(2nd PB
workshop)

Re: Final Site Plan Review Application – Commercial and Middle Street Mixed Use Development

COMMERCIAL & MAPLE STREET MIXED USE DEVELOPMENT 321 COMMERCIAL STREET

SITE PLAN/SUBDIVISION APPLICATION

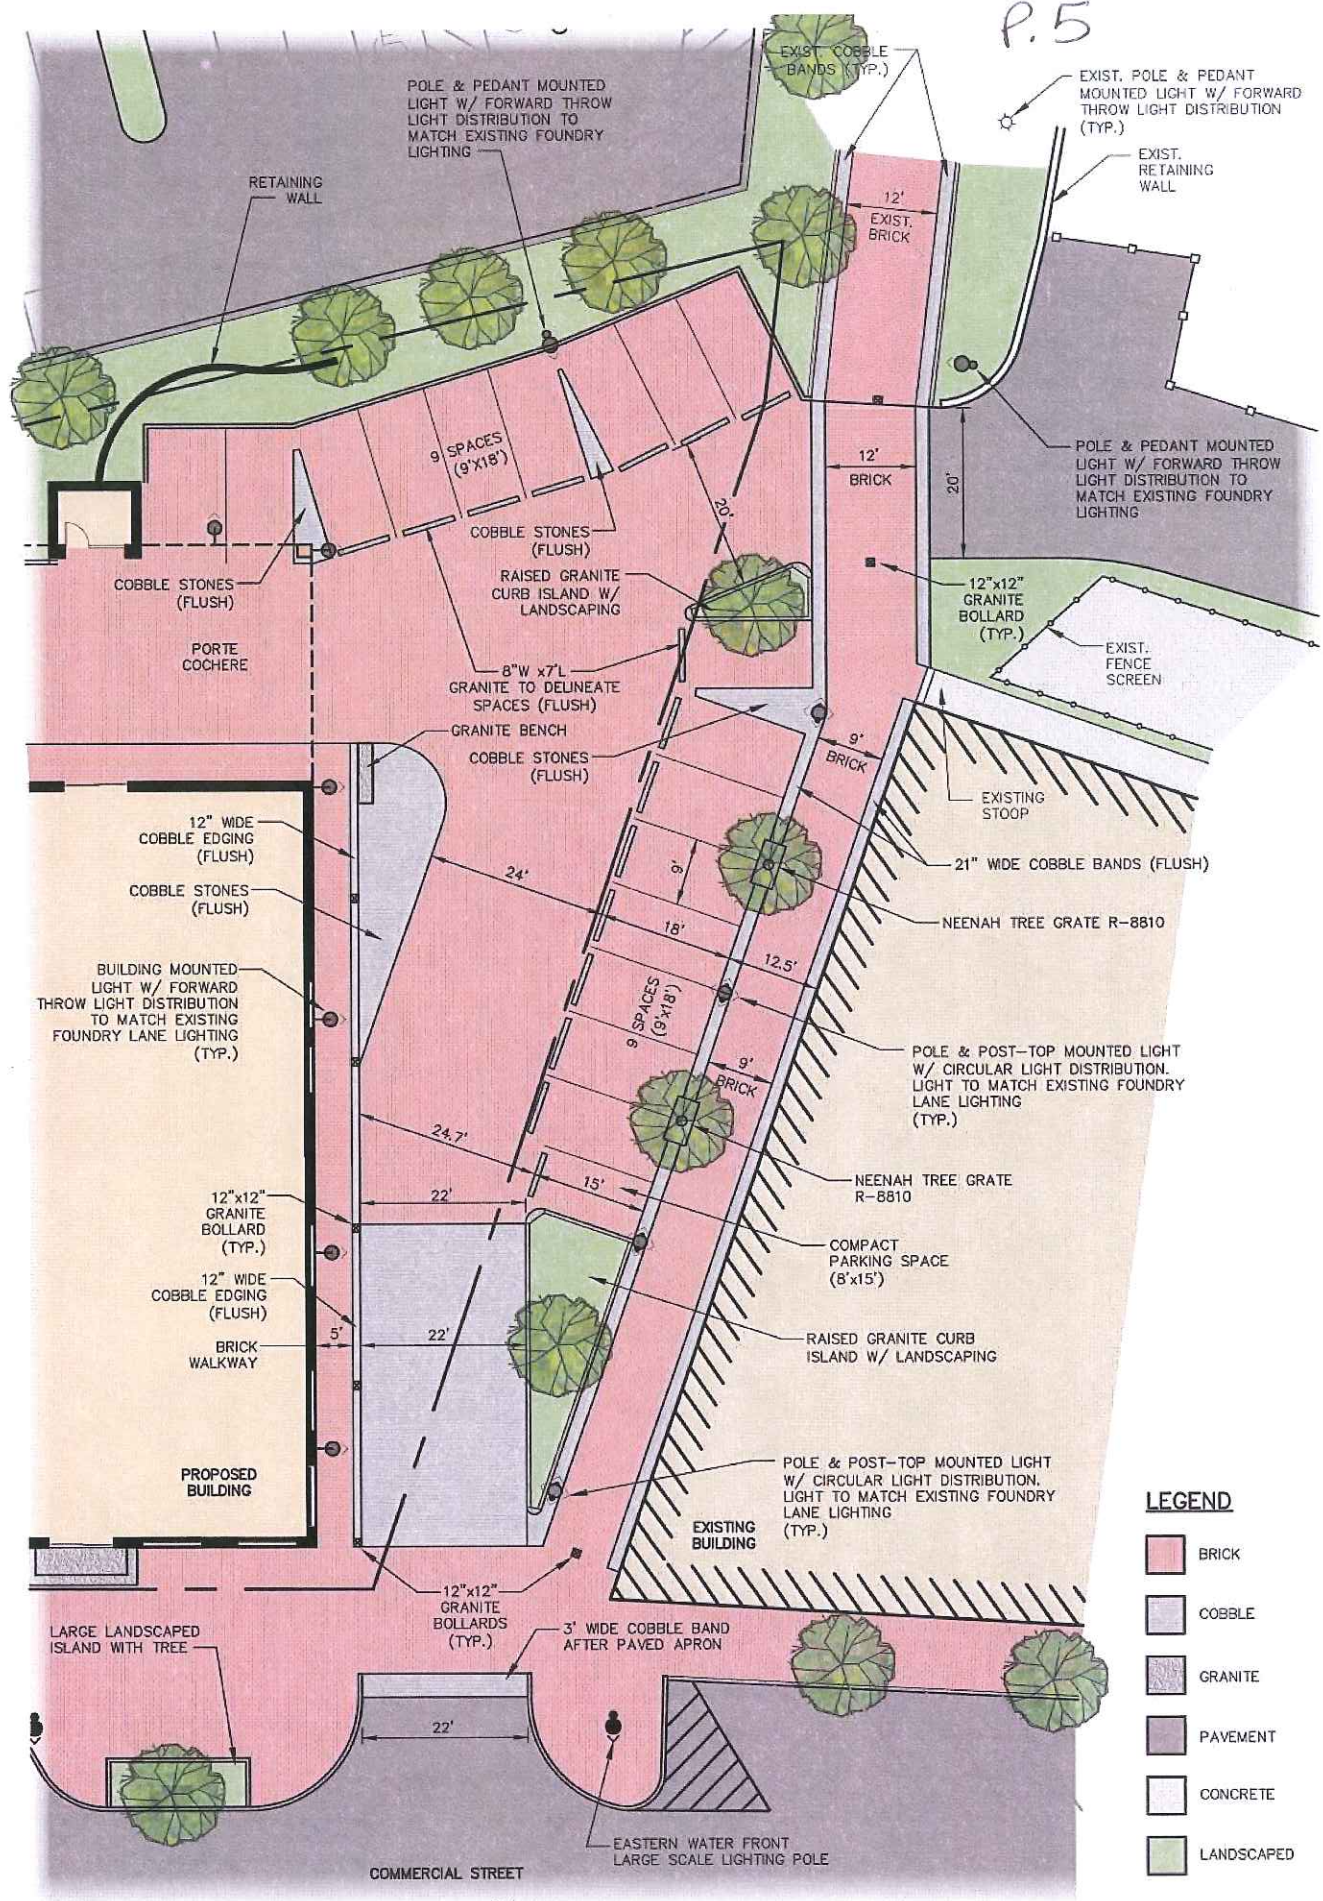
- The general concept is acceptable; the 22-foot entry width is acceptable. A few comments:
- The driveway at the location of the compact parking space is very tight. A vehicle parked in that space will extend out into the driveway and will reduce the effective width. A detail of this area illustrating how it will work is suggested.

- *The compact parking space is 15 feet in length as required and signage will be utilized to indicate compact cars only. Compact vehicles 15 feet in length or shorter will not extend into the parking aisle. To assist motorist in identifying parking space locations and length, we have added a flush granite stone "header" within the brick pavers. In addition, I have added parking aisle dimensions at this location to indicate a 22 feet at the aisle's most narrow width. This width will accommodate the turning maneuvers of a compact vehicle. A detail utilizing the turning template of a compact vehicle can be provided if the reviewer still deems it necessary.*
